Norfolk Boreas Offshore Wind Farm

Statement of Common Ground

Natural England

Applicant: Norfolk Boreas Limited
Document Reference: ExA.SoCG-17.D2.V2
Deadline: 2
Date: December 2019
Revision: Version 2
Author: Royal HaskoningDHV

Figure 1 *Sabellaria spinulosa* reef mapping by the Applicant and Natural England

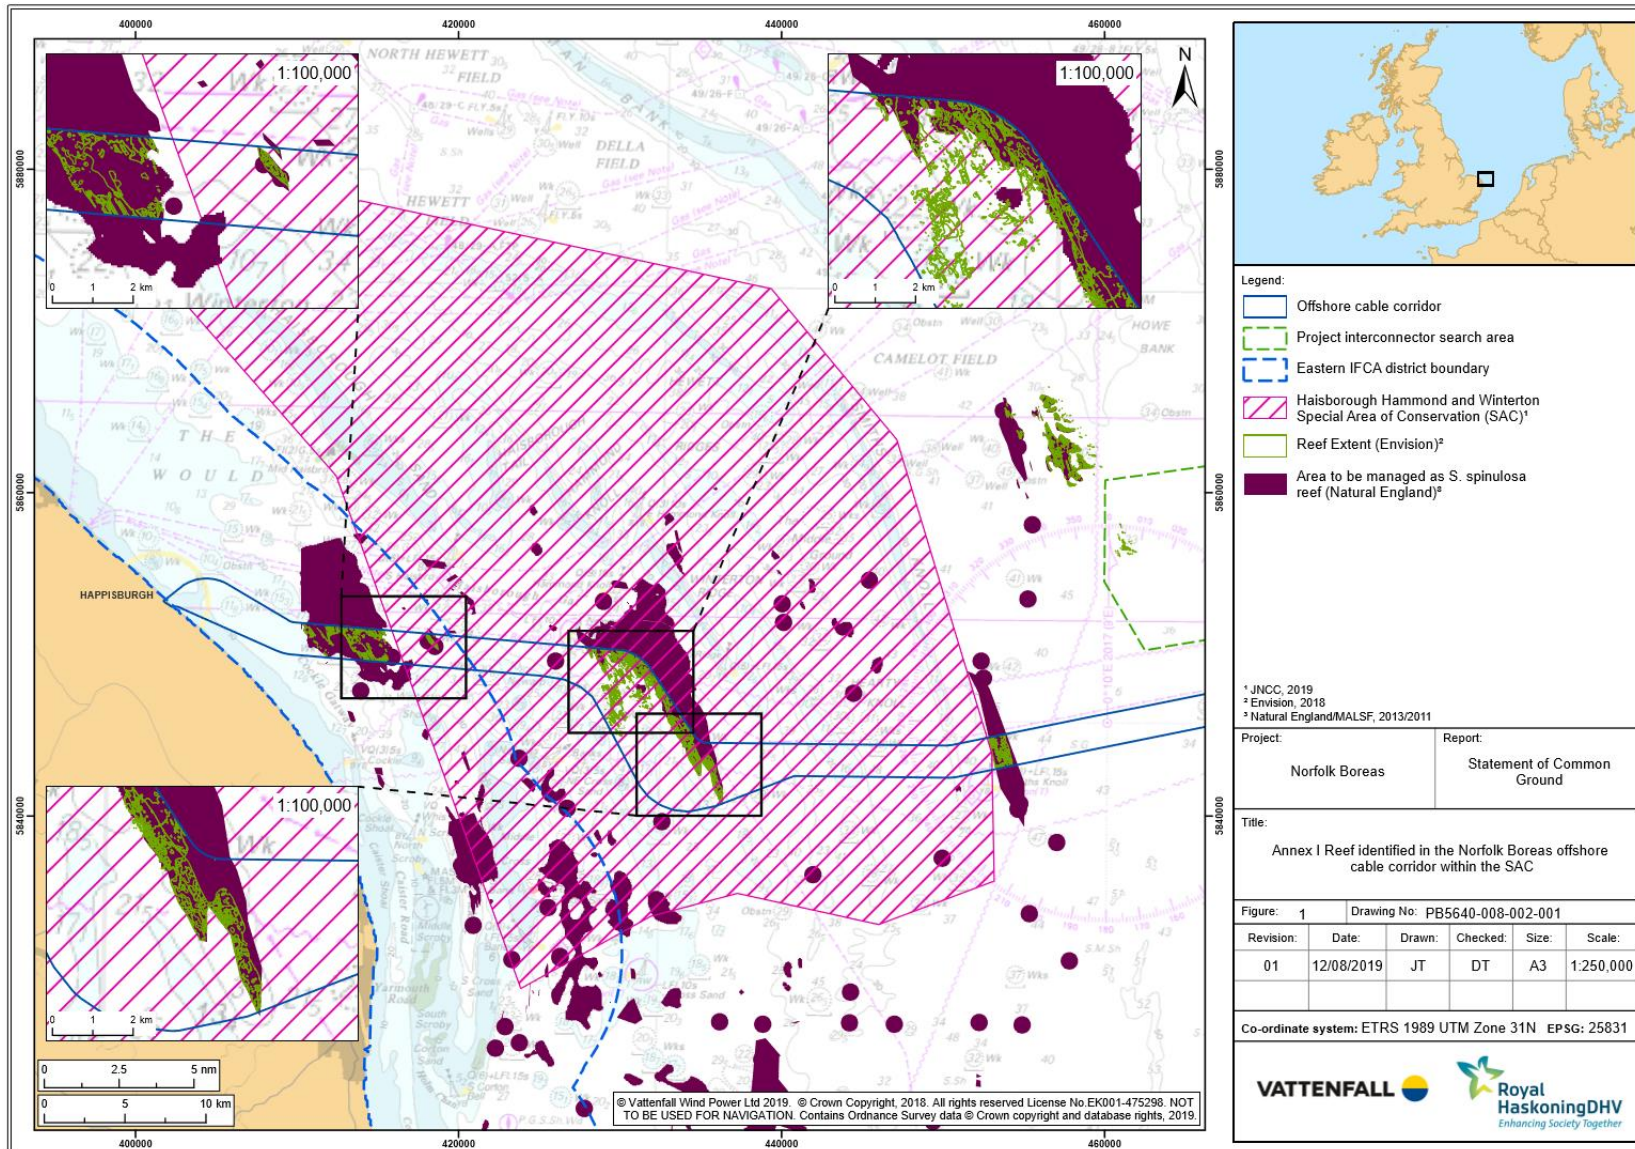
The approach to <i>S. spinulosa</i> reef mapping is appropriate to inform the EIA based on the data available.	Not agreed. Natural England has uncertainty associated with <i>S. spinulosa</i> reef mapping due to the ephemeral nature of the reef, the analytical use of a range of datasets, and the confidence levels applied to reef presence Appendix 2 (RR-099)	Area for ongoing discussion. (D2) Natural England are reviewing the

<p>The mapping of potential <i>S. spinulosa</i> reef by Envision on behalf of Norfolk Boreas (and Norfolk Vanguard Limited) identifies potential reef areas which are largely consistent with areas Natural England has identified (as shown on Figure 2.1 below).</p>	Agreed	Agreed
